Form 3160°5 (February 2005) UNITED STATES
DEPARTMENT OF THE INTERIOR
BUREAU OF LAND MANAGEMENT

SUNDRY NOTICES AND REPORTS ON WELLS

t. Unit or CA Agreement Name and No
1a Type of Well 🗸 Oıl Well 🗌 Gas Well 🔲 Other	FEB 2 2 2010	
	i i	B Well Name and No.
2 Name of Operator	NMOCD ARTESIA	Barclay 11M Federal 13
DEVON ENERGY PRODUCTION COMPANY, LP	LISTA	9 API Well No
3 Address and Telephone No.		30-015-32332
	405-235-3611	10 Field and Pool, or Exploratory

PECOS DISTRICT CONDITIONS OF APPROVAL

11" x 5,000 psi BOP Stack

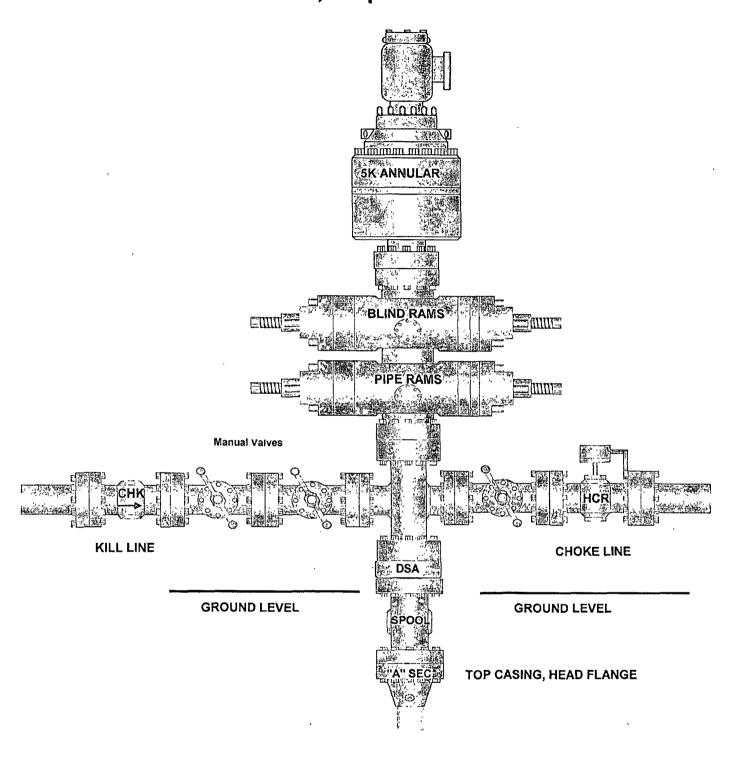
- 2. Minimum working pressure of the blowout preventer (BOP) and related equipment (BOPE) required for drilling below the surface casing shoe shall be 3000 (3M) psi.

- 3. Minimum working pressure of the blowout preventer (BOP) and related equipment (BOPE) required for drilling below the 8-5/8" intermediate casing shoe shall be 5000 (5M) psi. 5M system requires an HCR valve, remote kill line and annular to match. The remote kill line is to be installed prior to testing the system and tested to stack pressure.
